DTB

Date: April 23, 2009
 Order No.: S-B-03.30/08i
 Supersedes: S-B-03.30/08h dated October 24, 2008
 Group: 03

SUBJECT: Model 164.156/172/186/871/886
Model 171.454/456
Model 203.052/054/056/087/092
Model 204.054/056/081/987
Model 209.356/372/456/472
Model 211.056/072/087/090/256/287
Model 216.371/386
Model 219.372
Model 221.171/186
Model 230.471
Model 251.156/165
Equipped with M272 or M273 Engine
Check Engine Light On / Fault Codes Current and/or Stored in ME-SFI Control
Module / Oil Leaking at Camshaft Adjustment Solenoid

Figure 1 – Damaged/worn S-B-03.30/08a

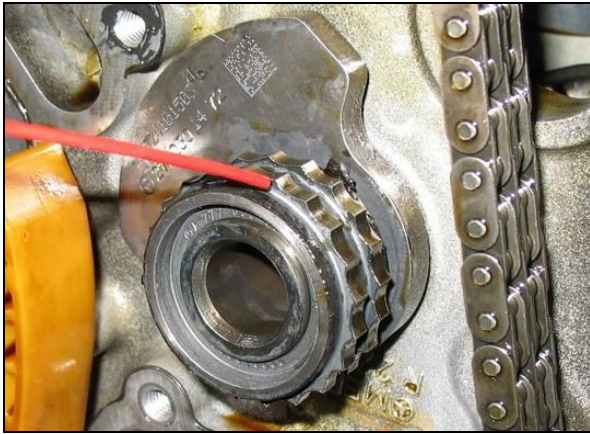
Fault Code Scenario 1: DTC 1200 and/or 1208 is/are present in ME-SFI control module. The fault codes are recorded as current and/or stored in the fault memory. When the fault memory is erased and the engine is restarted, the fault codes reoccur immediately. This is due to the positioning of the timing chain driven camshafts relative to the crankshaft and can be caused by a worn sprocket on the balance shaft on engine M272 or by a worn guide (idler) gear for the timing chain on engine M273. Figure 1, 2 and 3 show extremely worn sprocket gears. Figure 4, for comparison, shows a new sprocket gear.

- a) Perform a visual inspection for any wear of the teeth (damage profile) on the sprocket of the balance shaft (M272) or of the guide (idler) gear for timing chain (M273) by removing the timing case cover on the engine. Refer to WIS instructions AR01.40-P-8000* (* - applies to a specific model designation e.g. AR01.40-P-8000SX – models 221, 216). Ensure the use of the Special Tool W001 589 81 09 00 when removing / installing timing case cover.

i **Note:** Refer to Figure 1 through 3 for examples of damaged / worn sprocket profile. Refer to Figure 4 for example of a new gear (for comparison).

- b) Only if worn (sprocket teeth profile damaged), replace the balance shaft on engine M272 or replace the guide (idler) gear of the chain drive on engine M273 as per WIS instructions AR03.20-P-1000* (* - applies to a specific model designation e.g. AR03.20-P-1000VA – model 171).

Figure 5

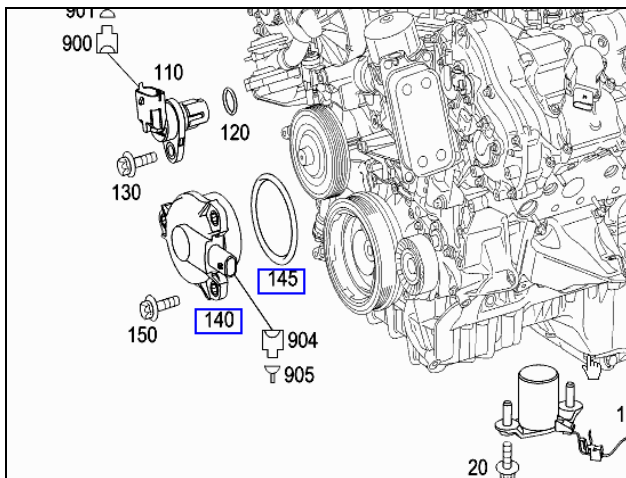
Fault Scenario 3: Camshaft adjustment solenoid is leaking oil, and no Fault Codes are current or stored in the ME Control Module. Determine the cause of the leak. The solenoid can be leaking from under the sealing ring or through the harness connector.

- a) If the leak appears to be between the solenoid and the cylinder head replace solenoid sealing ring (Figure 5, 145).
- b) If the leak is from the electrical connector, replace the solenoid (Figure 5, 140).
